**Response to Comments and Errata
for the**

**Old Arcata Road Rehabilitation &
Pedestrian/Bikeway Improvements**

SCH #2021010176

April 2021
Project Ref#: 11159130

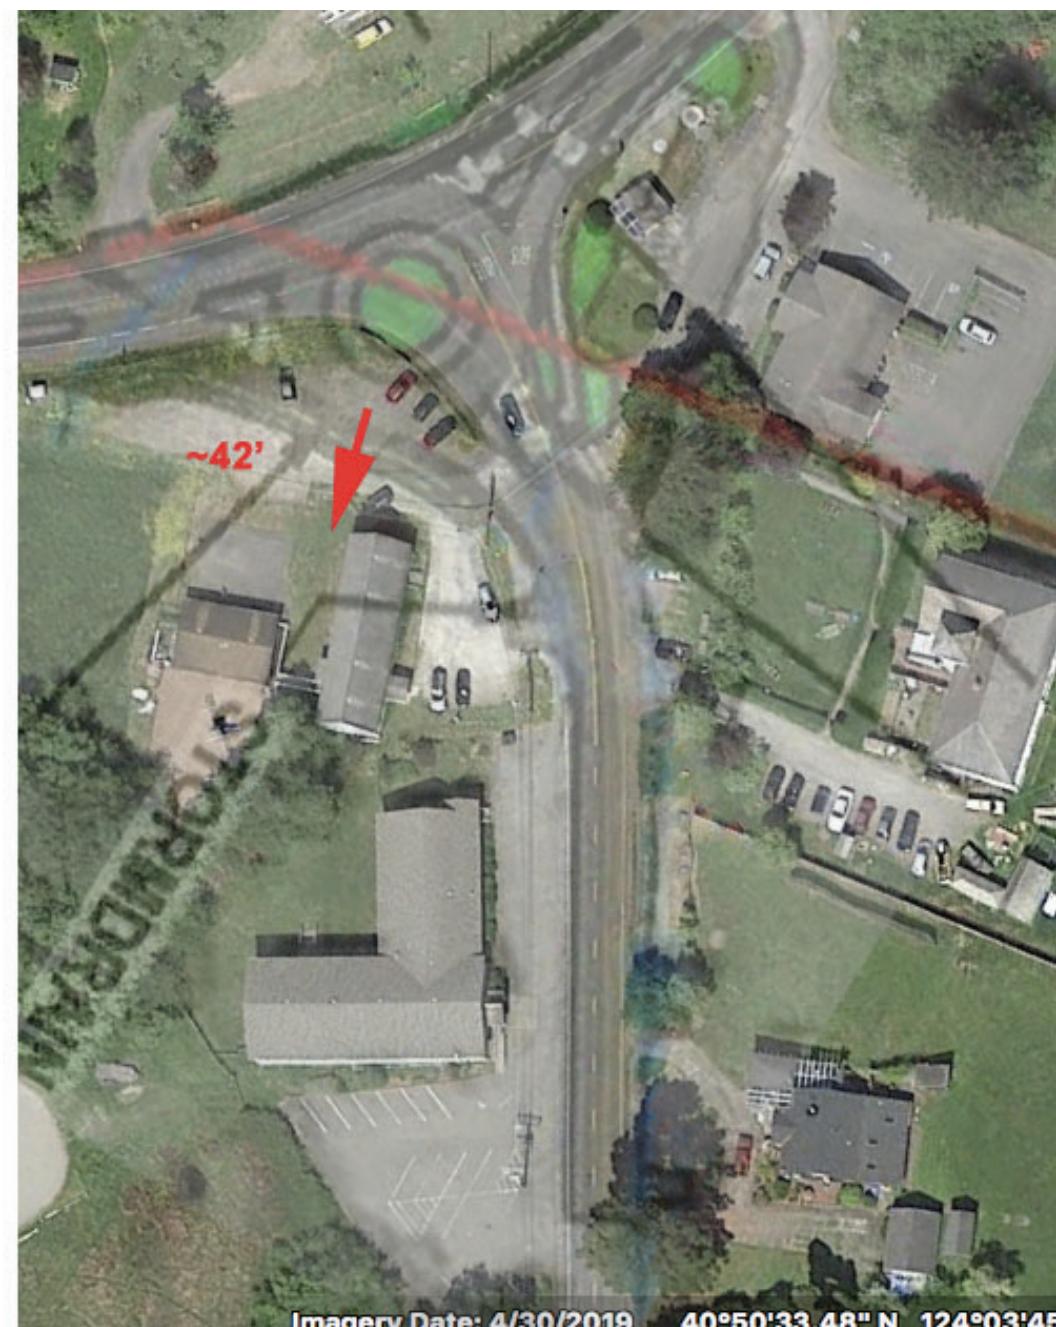
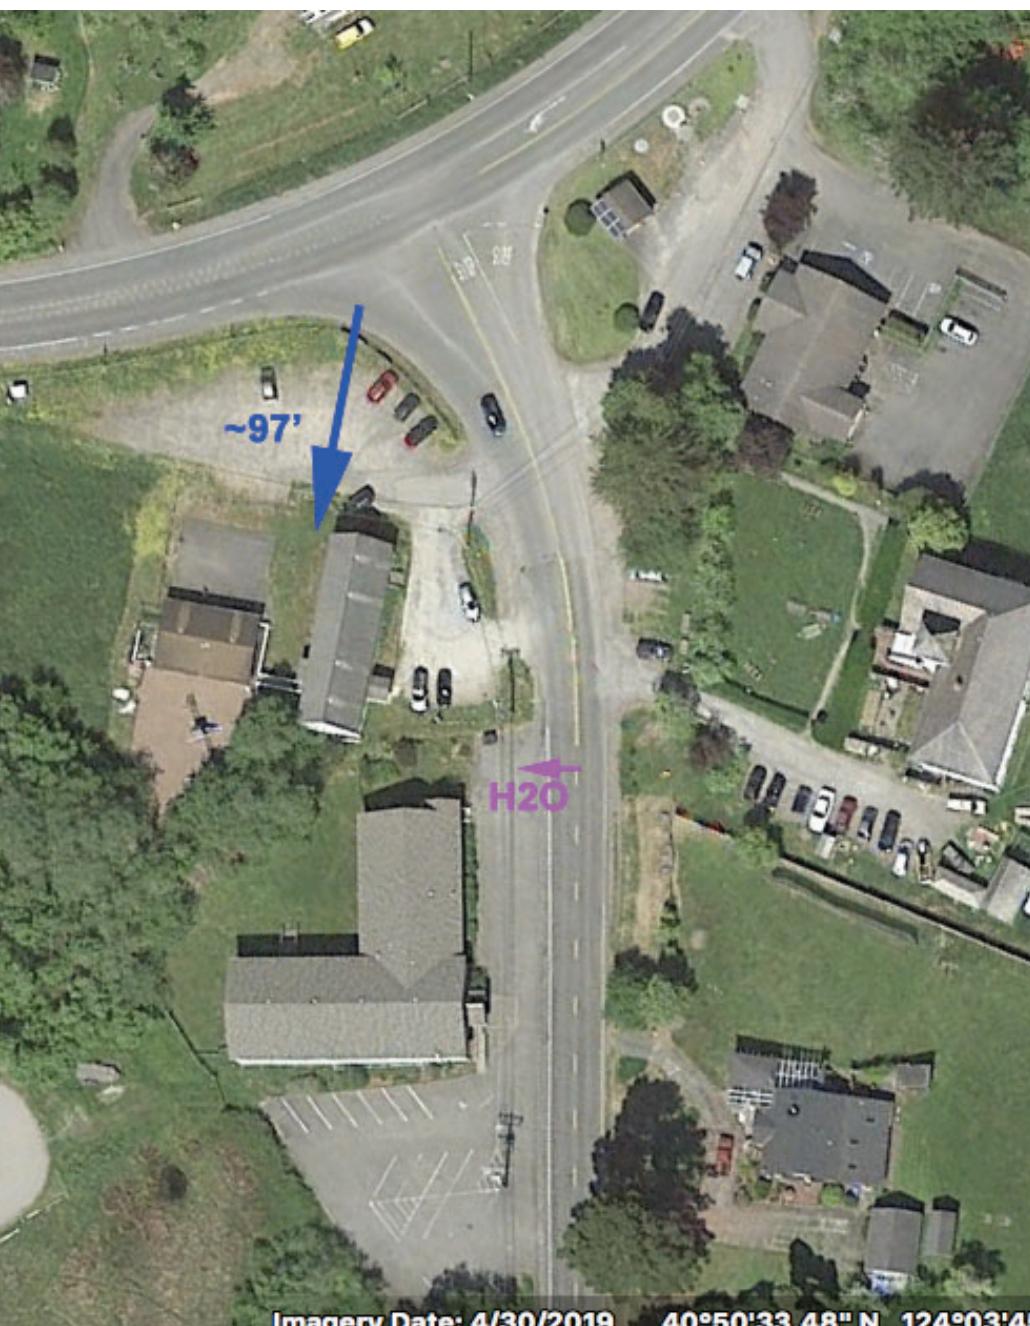
The difficulty is that there is no way to install a roundabout without encroaching into the parking area just west of Mistwood. I was having trouble visualizing exactly what is proposed, given that the MND coyly (and, at this stage, deceptively) states only that "some encroachments onto private property may be necessary and may require acquisitions or easements." "May be" indeed. So I overlaid the relevant portion of Figure 3 from the MND onto a Google Earth Pro image of the intersection – see accompanying figure.

As noted above, I've attached two figures, filenames "BCHParkingAtRisk.jpg" and "BCHParkingRoundaboutFigure.jpg" to illustrate/clarify some of my points.

Response 16-3 – Roundabout
